UNITED STATES PATENT AND TRADEMARK OFFICE

APPLICATION NO.	FILING DATE	FIRST NAMED INVENTOR	ATTORNEY DOCKET NO.	CONFIRMATION NO.
10/559,611	04/19/2006	Gilbert Ossbahr	82350	1507
26288	7590	10/04/2007	EXAMINER	
ALBIHNS STOCKHOLM AB BOX 5581, LINNEGATAN 2 SE-114 85 STOCKHOLM; SWEDEN STOCKHOLM, SWEDEN			AMIRI, NAHID	
			ART UNIT	PAPER NUMBER
			3679	
			MAIL DATE	DELIVERY MODE
			10/04/2007	PAPER

Office Action Summary	Application No. 10/559,611	Applicant(s) OSSBAHR, GILBERT	
	Examiner Nahid Amiri	Art Unit 3679

DETAILED ACTION

Fig.1

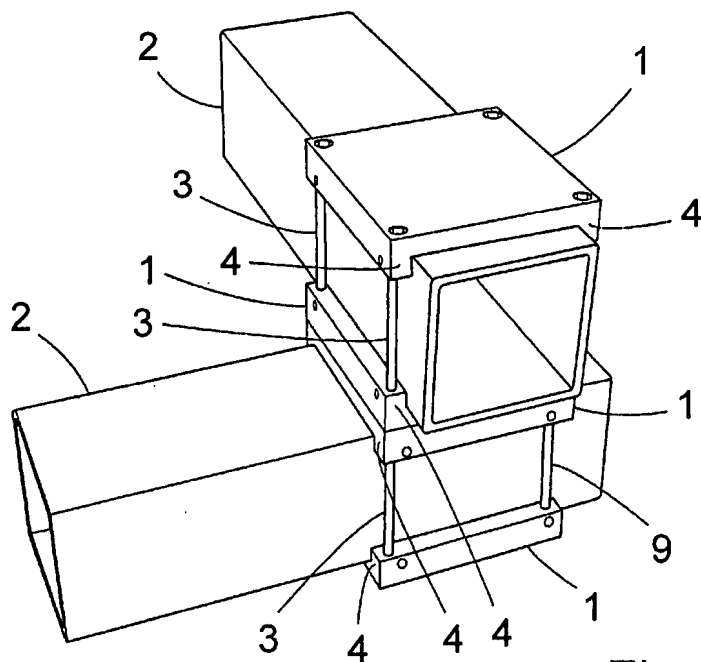
However, the drawings are objected to as failing to comply with 37 CFR 1.84(p)(4) because reference character "3" has been used to designate both "bolts" of Figs. 1-3 and the base of the "fixing plate 1" of Fig. 4. Corrected drawing sheets in compliance with 37 CFR 1.121(d) are required in reply to the Office action to avoid abandonment of the application. Any amended replacement drawing sheet should include all of the figures appearing on the immediate prior version of the sheet, even if only one figure is being amended. Each drawing sheet submitted after the filing date of an application must be labeled in the top margin as either "Replacement Sheet" or "New Sheet" pursuant to 37 CFR 1.121(d). If the changes are not accepted by the examiner, the applicant will be notified and informed of any required corrective action in the next Office action. The objection to the drawings will not be held in abeyance.
